# USB Type-C ENGINEERING CHANGE NOTICE

**Title: USB 2.0 Type-C receptacle**

**Applied to: USB Type-C Specification Release 1.2, Draft  
20160309**

Define a USB 2.0 Type-C receptacle.
-------------------------------------

Figure 3-9 Reference Footprint for a USB 2.0 Type-C Through Hole Right Angle Receptacle (Informative)

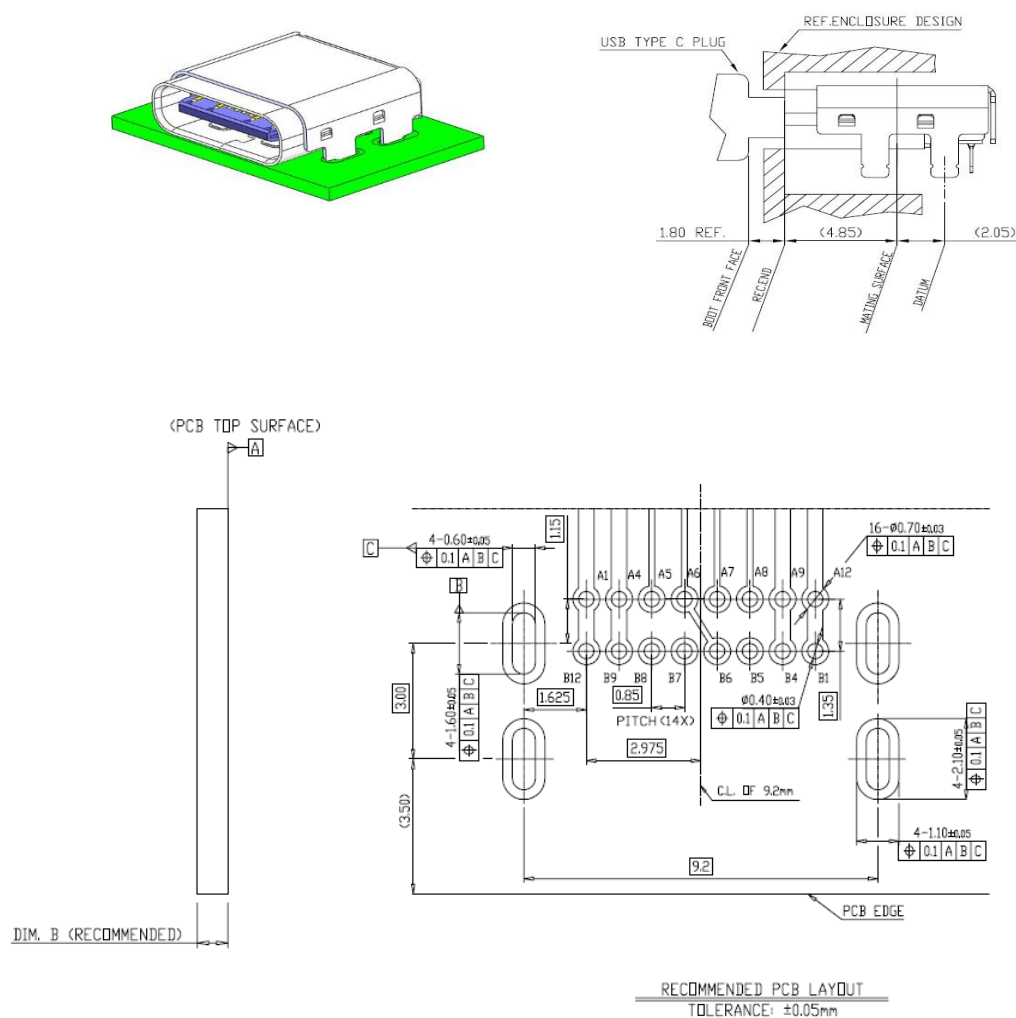
To: Add additional new Figure 3-9 and Figure 3-10 after Figure 3-8:
